## Index 430-030

### Stright Concrete Endwalls Single and Multiple Pipe

#### COMMENTARY

FRONT ELEVATION

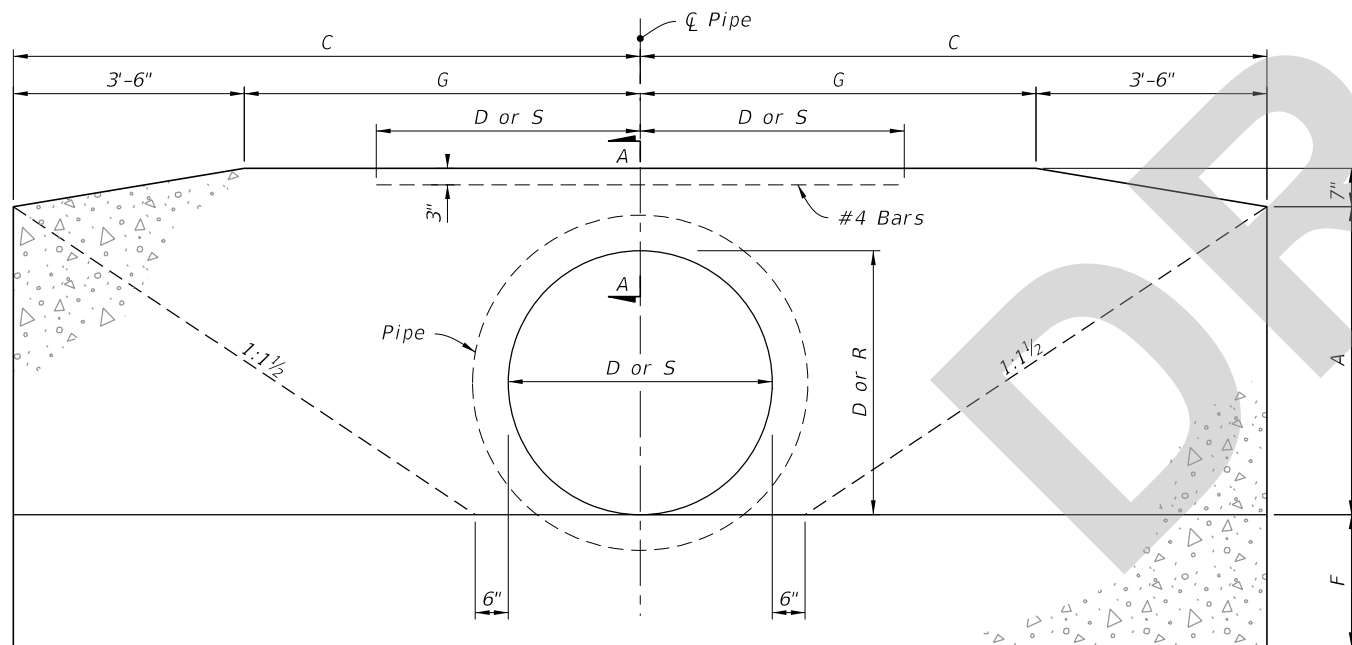
**COMMENT:** Please consider adding a cut section callout to the “Front Elevation” and label the new details “Section A-A” instead of Detail B for clarity of what the detail represent.

**RESPONSE:** Thank you for the comment. The Index will be updated to reflect the suggested changes.

**CHANGE MADE TO INDEX:** Yes.

SECTION A-A

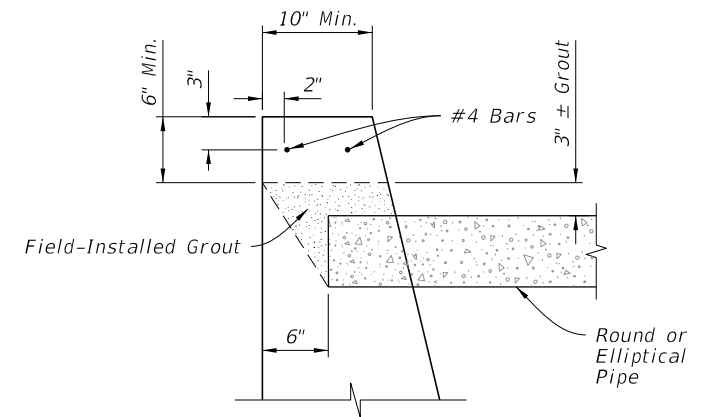
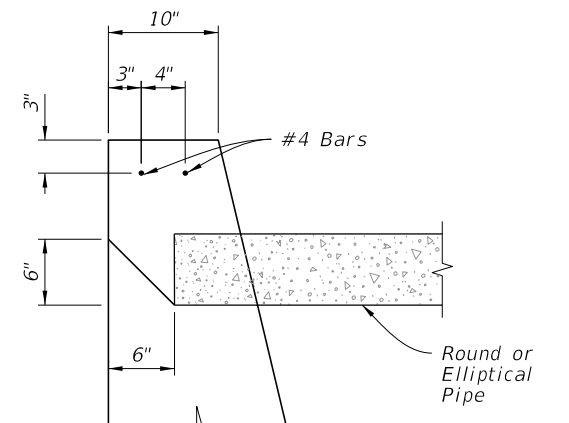
**COMMENT:** Good morning, we need to add the following to option #1 in reference to the fillet that joins the headwall and the pipe - "Pipe fillet installed in field by others".

**COMMENT:** The new option does not address the 6" of pipestop that should be included as grouted in the field in most precast endwalls. It is included in the QCP submissions that have accepted by FDOT already.

**RESPONSE:** Agreed. This callout will be updated to reflect that the grout is field installed.

**CHANGE MADE TO INDEX:** Yes. Changed "Grout" to "Field Installed Grout"

**RESPONSE:** Thank you for your comment. The 3" +/- callout is reflecting the OD+6" assuming a relatively centered pipe.

**CHANGE MADE TO INDEX:** Yes. Changed “Grout” to “Field Installed Grout”
